Access Compliance Report

Public Rights-of-Way

(Curb Ramps)

Intersection ID: 49274	Main Street: ROTHE_HOUSE_RD	Cross Street: REMINISCE_LN	Location: E
ADA ID: F0E2CDF14C04	Ramp Type: PerpDiag	Initial Pass/Fail: Fail	Overall Compliance: No
Severity Score: 13.75			
Codes/Mitigation Info/Possible Solution		Field Measurements/Component Compliance

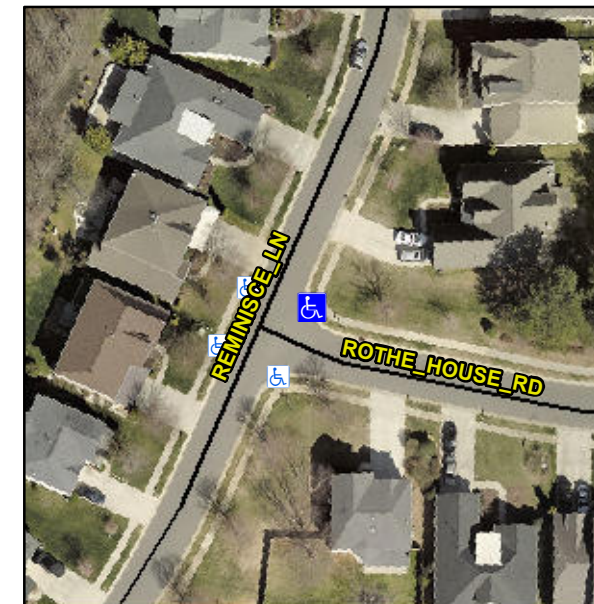
Not Found, R304.2.2, R304.5.3

Compliance	Description	Data	Compliance	Description	Data
N/A	Ramp Length (in)	47.5	No	Ramp Slope (%)	10.9
Yes	Ramp Width (in)	48.0	No	Ramp XSlope (%)	2.7
N/A	Flare Type LT	N/A	N/A	Flare Type RT	N/A
N/A	Flare Slope LT (%)	N/A	N/A	Flare Slope RT (%)	N/A
N/A	Flare Traversable LT?	N/A	N/A	Flare Traversable RT?	N/A
N/A	Landing Length (in)	N/A	N/A	DWS Provided?	N/A
N/A	Landing Width (in)	N/A	N/A	DWS Contrast?	N/A
N/A	Landing Slope (%)	N/A	N/A	DWS Length (in)	N/A
N/A	Landing X Slope (%)	N/A	N/A	DWS Full Width?	N/A
N/A	Landing Curb? (Y/N)	N/A	N/A	DWS Offset (in)	N/A
N/A	Shared Landing?	N/A			
N/A	Gutter Ponding?	N/A	N/A	Gutter Slope (%)	N/A
N/A	Gutter Lip Ht (in)	N/A	N/A	Gutter X Slope (%)	N/A
N/A	Painted X Walk1?	No	N/A	Painted X Walk2?	No
	X Walk 1 Direction	To NW		X Walk 2 Direction	To SW
N/A	X Walk 1 Width (in)	N/A	N/A	X Walk 2 Width (in)	N/A
	X Walk 1 Slope (%)	1.1		X Walk 2 Slope (%)	2.5
	X Walk 1 X Slope (%)	3.1		X Walk 2 X Slope (%)	2.4

Remove & Replace Curb Ramp With Two New Directional Ramps or Equivalent.
